Subject: Calculations for Indian Point-2
Storage Racks

The calculations requested by the Division of Systems Integration¹ (DSI) in support of the USNRC review of the Indian Point-2 (IP-2) Fuel Storage Rack Submittal² have been completed.

FIG. 1 REFERENCE IP-2 FUEL STORAGE RACK CONFIGURATION

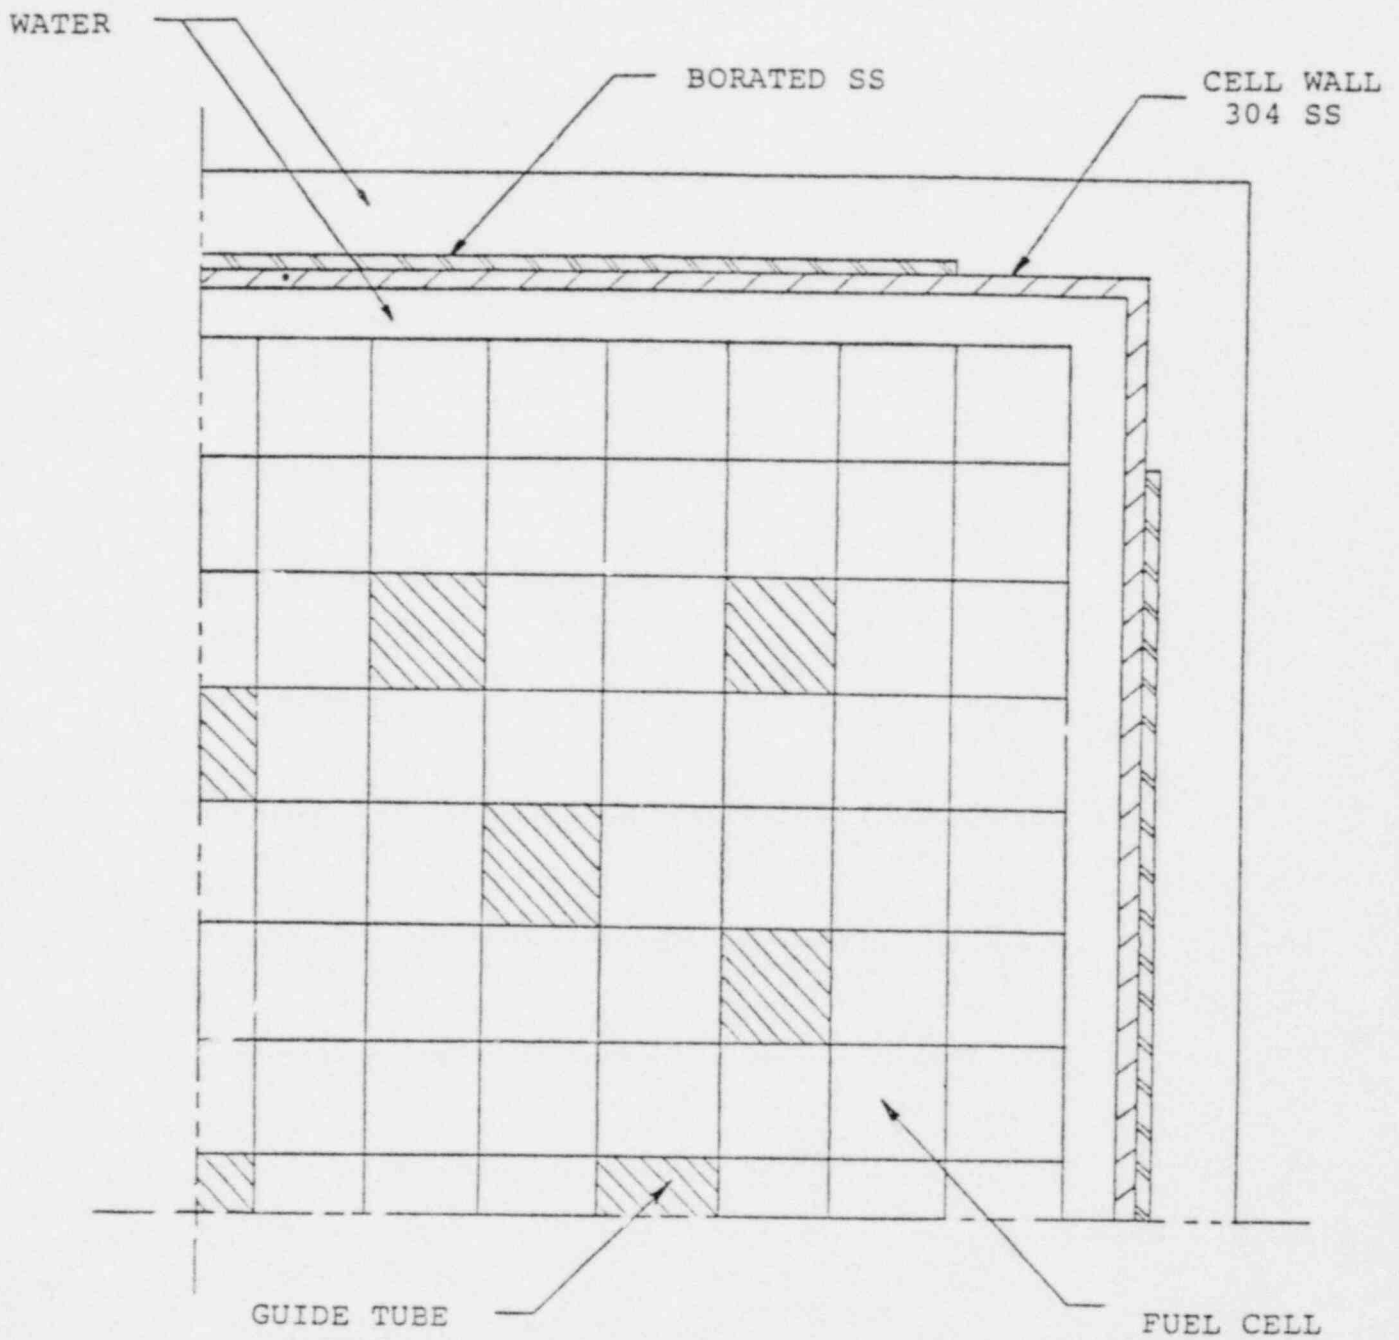
The simulation of the reference IP-2 fuel storage rack configuration represented an infinite array of fuel storage cells with centrally located Westinghouse 15 x 15 fuel assemblies (cf. Figure 1). The fuel was assumed to be 3.5 w/o enriched UO_2 . One-eighth of the cell was represented with a 100cm axial dimension, and reflecting boundary conditions on all exterior surfaces. The fuel pellet, gap and cladding, as well as the guide tubes, were explicitly modelled. Number densities for the fuel assembly were calculated from data presented in References 2 and 5. Number densities for the water,

The eigenvalue for this configuration (20,000 neutron histories, 500/batch) was 0.938 ± 0.007 at the 1σ confidence level with the Maximum Likelihood Estimator used in SAM-F. This result is in substantial agreement with the result presented in Reference 2 which was obtained with a totally different calculational procedure.

The result from the SAM-F calculation for the reference IP-2 fuel storage rack configuration essentially confirms the k_{eff} of 0.933 ± 0.006 reported in the IP-2 submittal. The submittal, however, sheds little or no light on a number of areas relating to whether or not the IP-2 design can be expected to satisfy the NRC criteria for fuel storage racks.

The procedure employed in the IP-2 submittal in order to account for expected deviations from the reference configuration also raises some questions. The deviations considered include variations in the borated poison sheet thickness, poison concentration, storage cell pitch, etc. The Δk_{eff} 's resulting from possible deviations from the reference configuration were determined using a standard multigroup diffusion theory program. (It should be noted, however, that diffusion theory might be inadequate for an accurate assessment of the effects of some of the perturbations considered.) The resultant Δk_{eff} 's then appear to have been treated as standard deviations, and combined in a root-mean-square fashion with the uncertainty from the KENO-IV Monte Carlo calculation in order to yield an overall uncertainty for what is called the "worst case normal configuration."

It is not intuitively clear to these authors that root-mean-square formality quantifies the philosophical statement of "worst case" analysis. All the individual perturbations considered, when viewed in the context of reactor physics, tend to categorize themselves into two distinct partitions - a) changes in the effective amount of moderation and b) changes in the ratio of fission to poison. One should, thus, separately ask the question about true event independence within three contexts - two simultaneously occurring reactivity producing events that are i) both essentially changes in moderation, ii) both essentially changes in the fission to poison ratio, and iii) a change in moderation coupled with a change in the fission to poison ratio. If the events are truly independent then the root mean square formalism has some statistical merit. If, however, the Δk_{eff} are not truly independent then a more detailed investigation of the combining of the uncertainties is probably required.
